**SUBDIVISION &
ZONING AMENDMENT STAFF REPORT**

Date: August 17, 2017

SUBDIVISION NAME Bayview Heights Subdivision, Resubdivision

LOCATION 3915 & 3921 Cottage Hill Road
(South side of Cottage Hill Road, 235'± East of Azalea Road, extending to the North side of Shelley Drive, 215'± East of Azalea Road).

DETAIL SITE PLAN

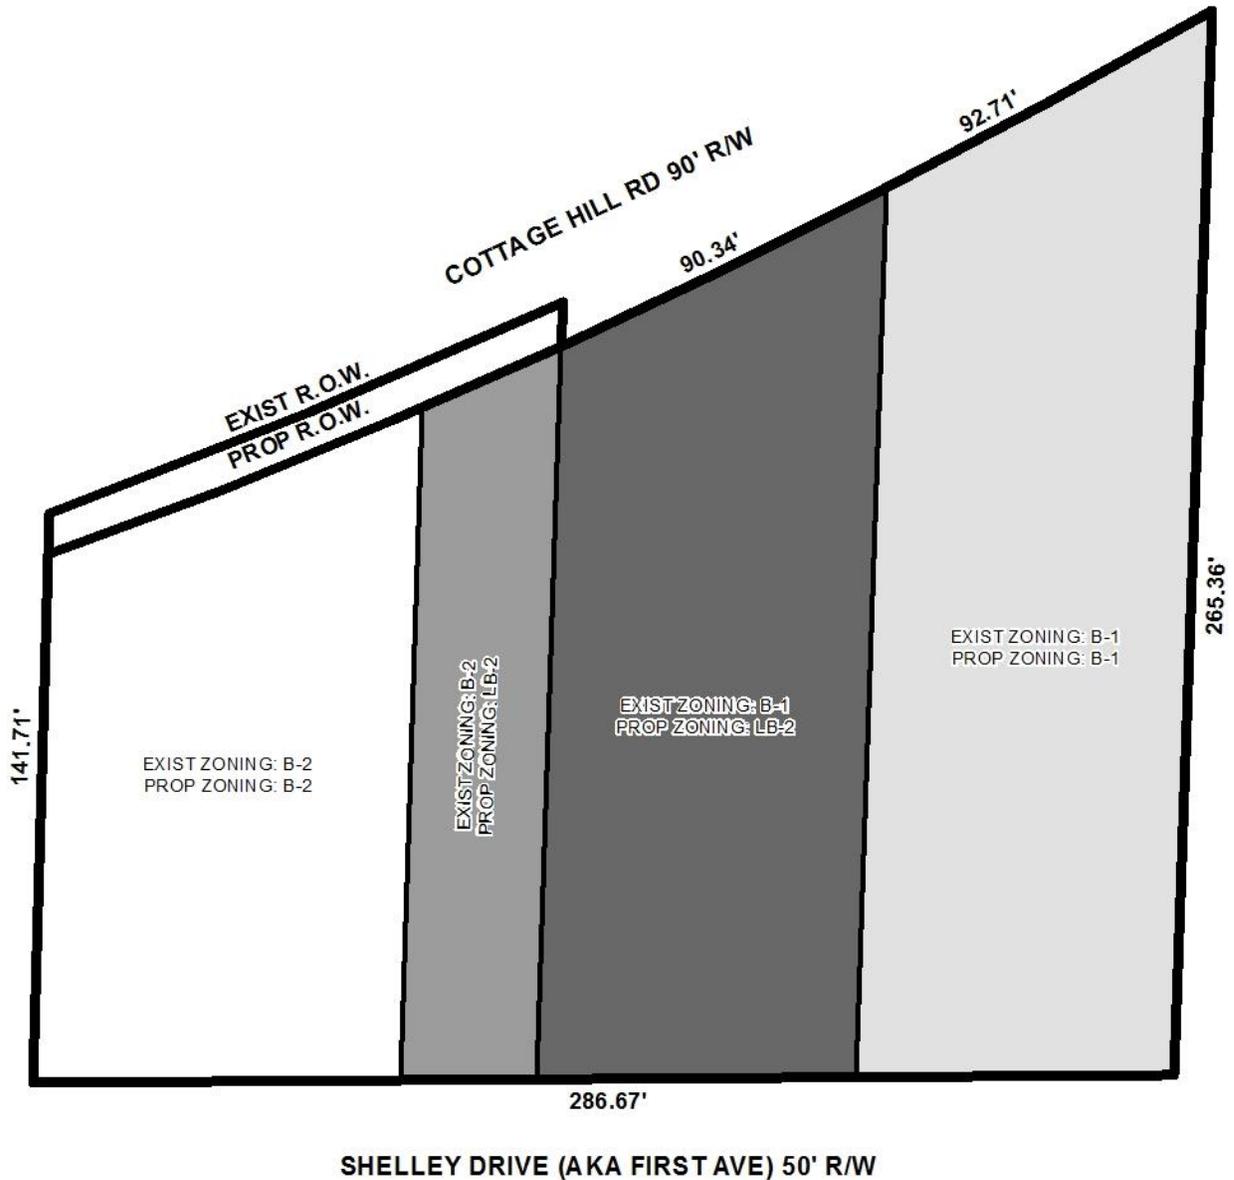
The site plan submitted illustrates a 1,500 square foot restaurant with a drive-thru and a small patio area (size not provided). The minimum required amount of parking spaces for the restaurant is 15, although if the patio is to be used for outdoor seating, could increase the parking requirements slightly. The site plan illustrates 17 parking spaces to be provided.

It should be noted that no tree planting or landscaped area calculations were provided on the site plan, however it should be noted that full compliance with these regulations will be required at the time of development.

The site plan indicates a dumpster with a masonry enclosure to the South of the property; however, it is located within the required 25' setback along Shelley Drive. If approved, it should be noted that the dumpster must be relocated outside of all required setbacks, and must be connected to sanitary sewer as well as within a compliant enclosure.

A drive thru is being proposed for the restaurant. Queuing spaces are shown, and it appears that there are adequate queuing spaces available. If approved, proper queuing spaces should be retained on the site.

It appears that a sidewalk is illustrated along both Cottage Hill Road and Shelley Drive, but is not labeled along Shelley Drive. A sidewalk will be required at the time of development along both public street frontages.
